Registry No. F00558

Sublocality Womens Bay Approaches and Harbor

Descriptive Report to Accompany Hydrographic Survey F00558

Project OPR-P136-RA-08
North Coast of Kodiak Island, Alaska
Womens Bay Approaches and Harbor
Scale 1:10,000
July 24-July 28
NOAA Ship *Rainier* (s221)
Chief of Party: Captain Donald W. Haines, NOAA

Figure 10: Charted (AWOIS 52-462) on chart 16596

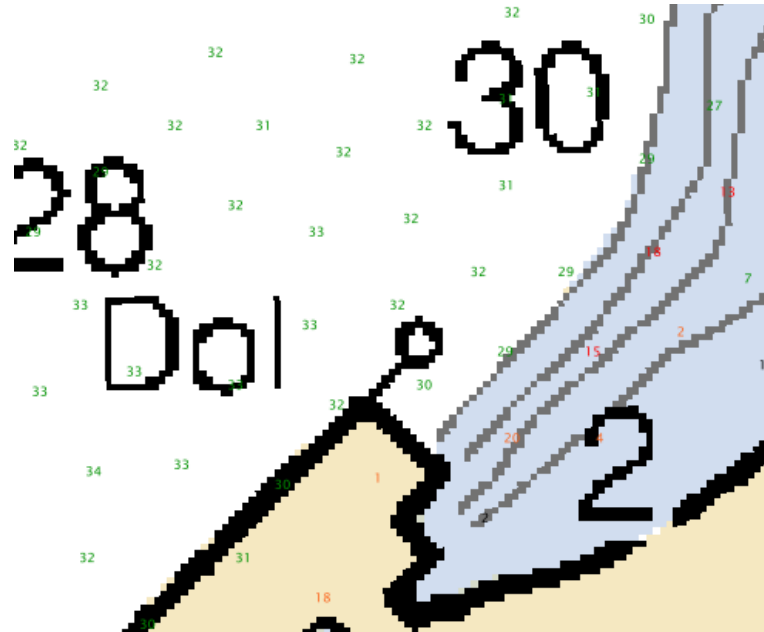
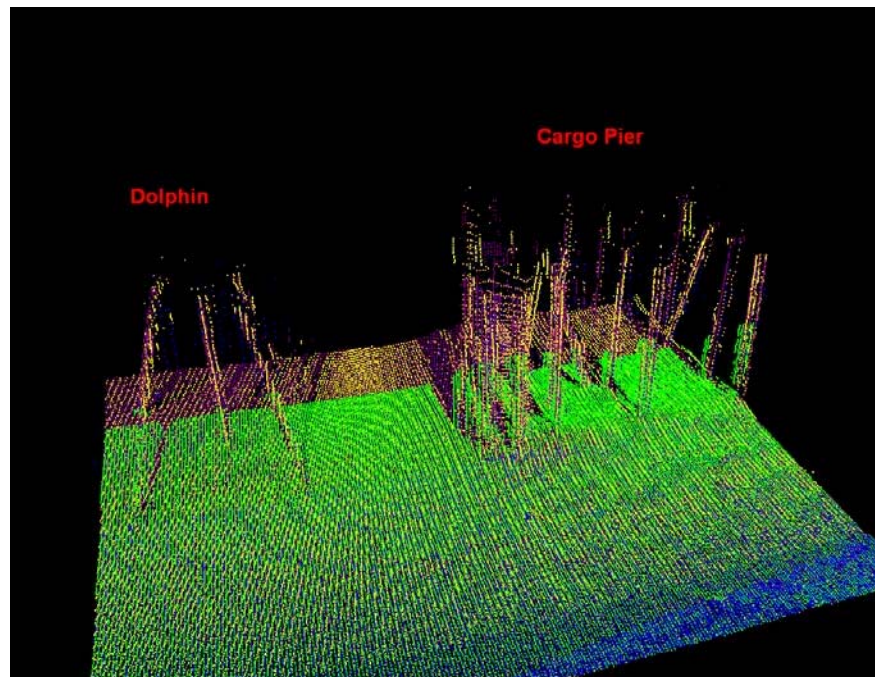
The charted dolphin (AWOIS 52-462) located at the northeast end of the Cargo Pier in Womens Bay Harbor, as illustrated in Figures 10 and 11, was seen from the surface and detected with MBES. The Hydrographer recommends repositioning the charted dolphin as per the digital MBES data and field verified hob file.²⁰

- ¹⁴ Concur.
- ¹⁵ Concur.
- ¹⁶ Concur.
- ¹⁷ Concur.
- ¹⁸ Concur.
- ¹⁹ Concur.
- ²⁰ Concur with clarification. Chart per F00558_CS.000.
- ²¹ Concur with clarification. Chart per F00558_CS.000.

Figure 12: Charted (AWOIS 53-696) on chart 1659, the “0” sounding indicates the surveyed location of the dolphin

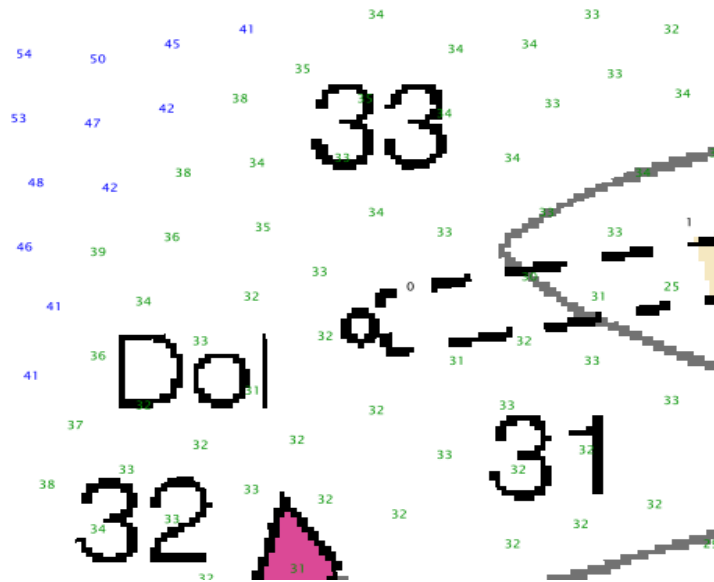
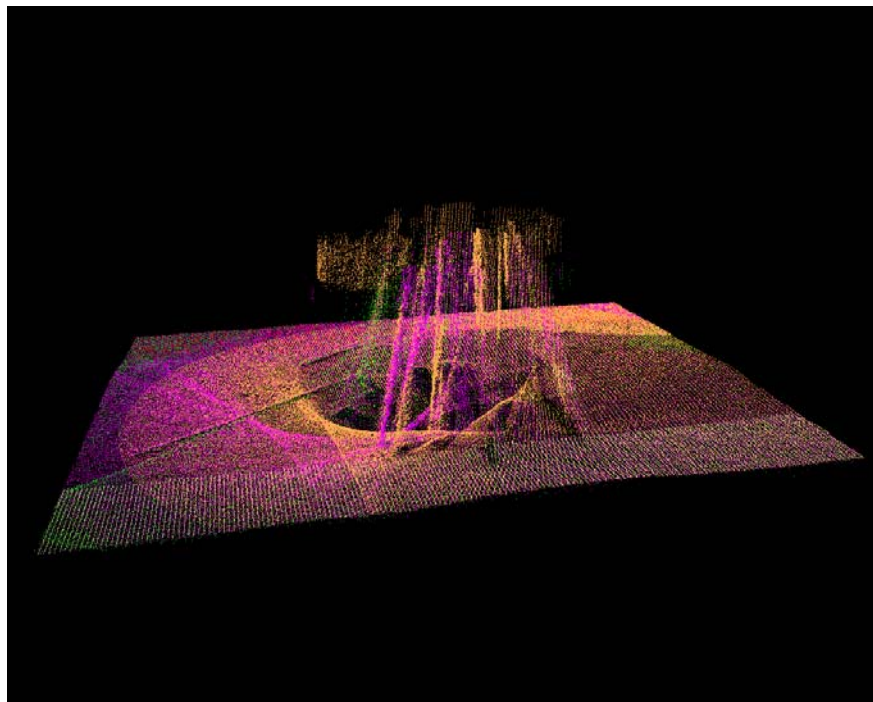
The charted dolphin (AWOIS 53-696) located at the west end of the Fuel Pier in Womens Bay Harbor, as illustrated in Figure 12, was observed from the surface and detected with complete MBES. The charted position of the dolphin does not correspond with the surveyed position. Construction has taken place on this pier since the item was last investigated in 1999: there is a walkway that extends from the fuel pier to the dolphin where the currently charted submerged pier ruins are charted. The positions and status of the pier and dolphin have been updated in the Notebook hob files. The Hydrographer recommends charting the dolphin and fuel pier as per the field verified hob file.²¹

Figure 14: Charted (AWOIS 52-460) overlaid on chart 16596

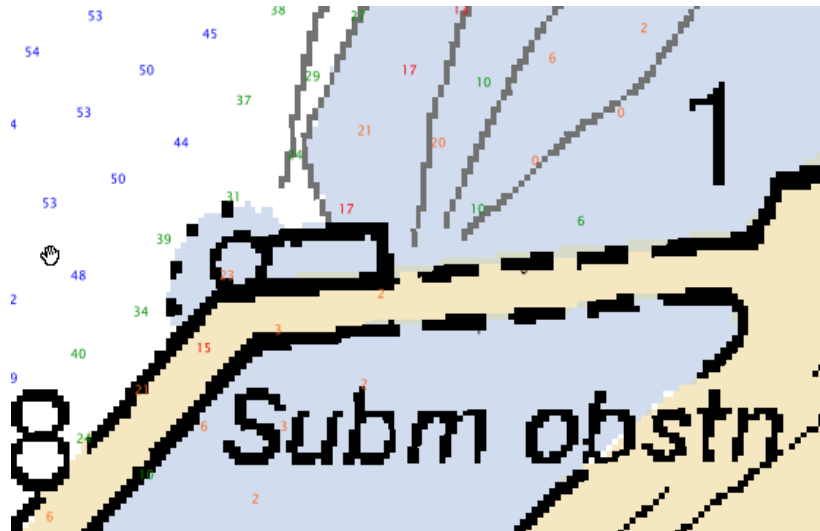
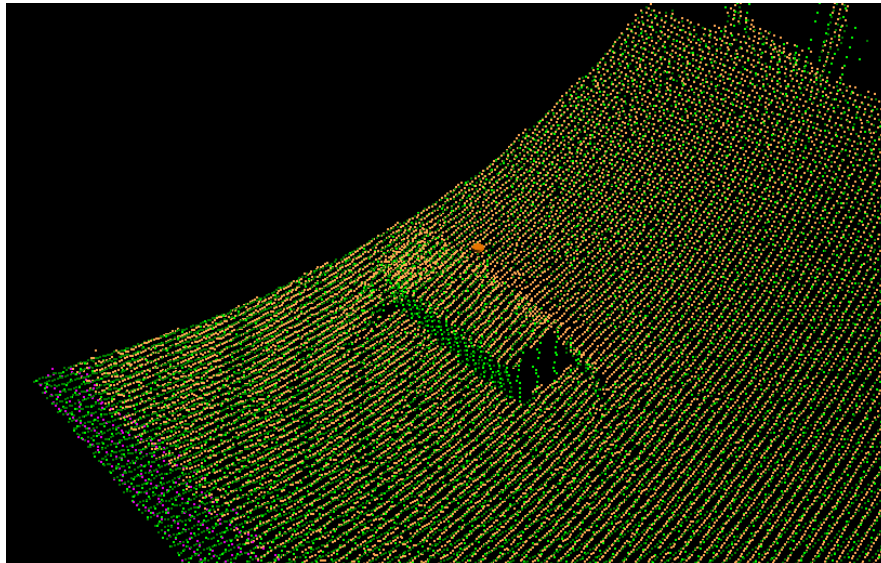
The charted submerged obstruction feature (AWOIS 52-460) located at the northeast corner of Marginal Pier in Womens Bay Harbor, as illustrated in Figure 14, was investigated with MBES. Although several insignificant features were identified at the charted position, the most significant contact in the area is approximately 20 m to the north east of the charted position, Figure 15. This obstruction has a least depth of 5.50 m (18 ft). The Hydrographer recommends removing the current charted obstruction and charting the obstruction identified as per the field verified hob file and supporting MBES data.²²

- ²² Concur with clarification. Chart per F00558_CS.000.
- ²³ Concur.
- ²⁴ Concur.
- ²⁵ Concur.
- ²⁶ Concur with clarification. Chart per F00558_CS.000.
- ²⁷ Concur with clarification. Chart per F00558_CS.000.

Figure 22: Uncharted submerged piles on CARIS BASE surface

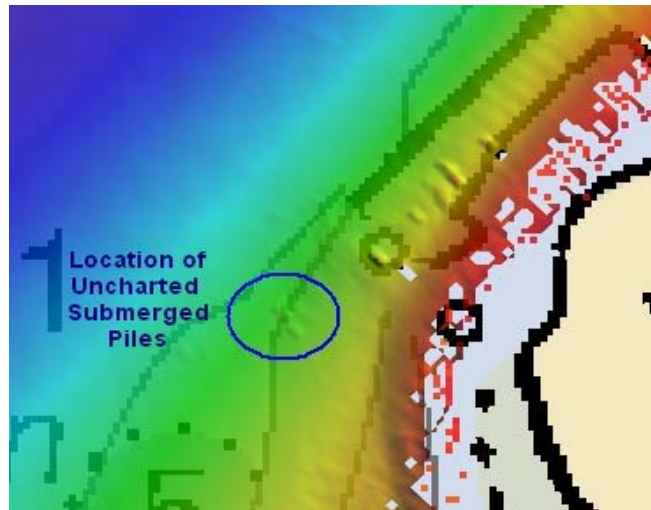
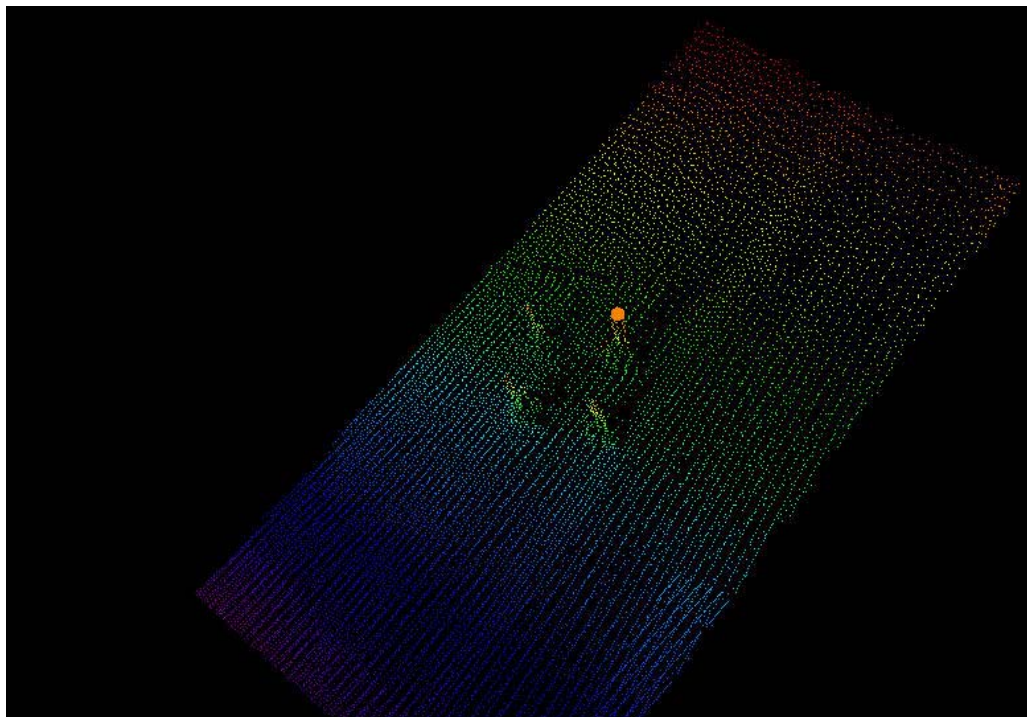
Four uncharted submerged piles were found in the bathymetry located off the southwest end of Marginal Pier in Womens Bay Harbor. See Figure 22. The uncharted submerged piles were detected with MBES, as illustrated in Figure 23, and surveyed to a least depth of 5.62 m (18.4 ft). The least depth on the shoalest submerged pile is designated in CARIS and is represented as submerged piles in the Field Verified hob file. The Hydrographer recommends charting “submerged piles” as per the digital data.²⁶

Figure 24: Shoal area depicted on CARIS BASE surface

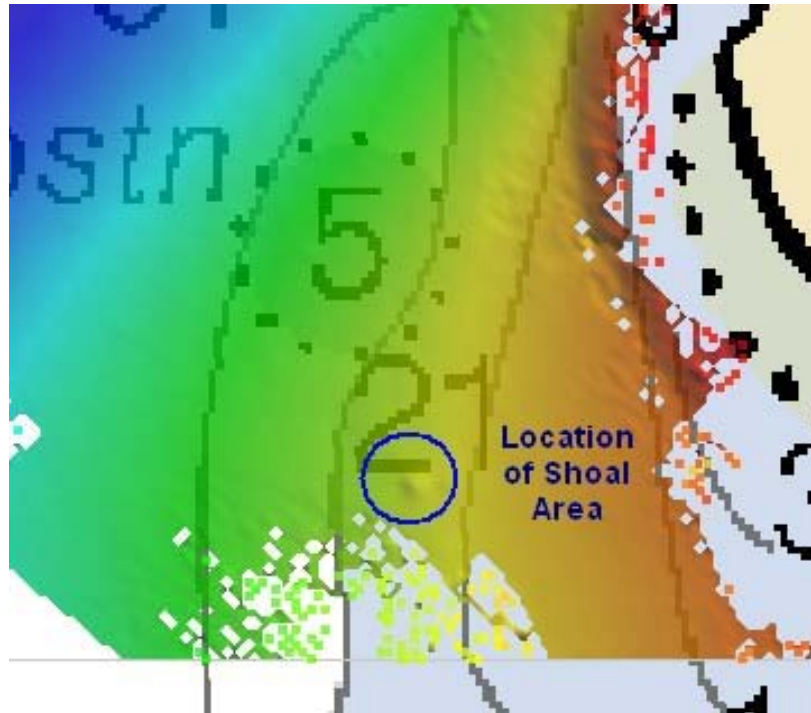
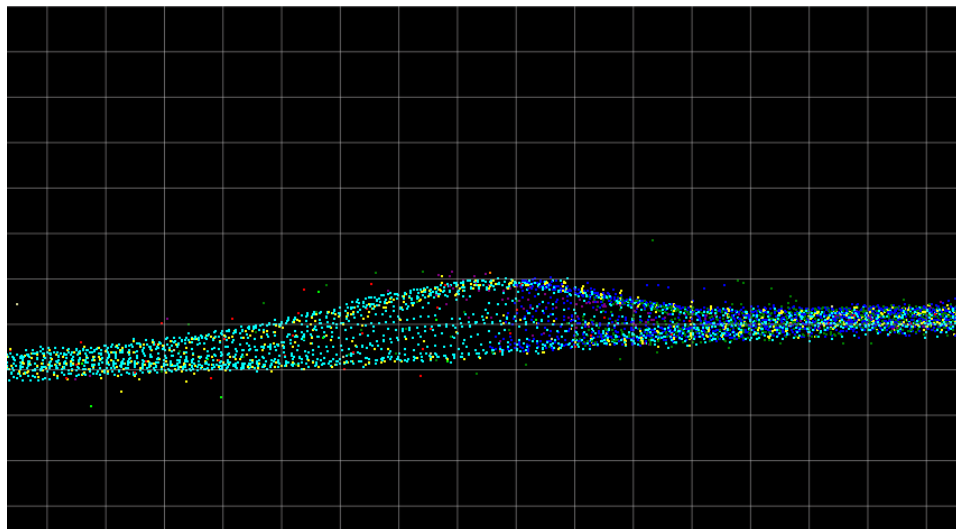
A shoal was located south of the charted 21 foot sounding southwest of Marginal Pier in Womens Bay Harbor. (See Figure 24) This shoal area was detected with MBES, as depicted in Figure 25, and the least depth of 5.33 m (17.5) feet was designated in Caris. The Hydrographer recommends charting the shoal as per the digital sounding data.²⁷
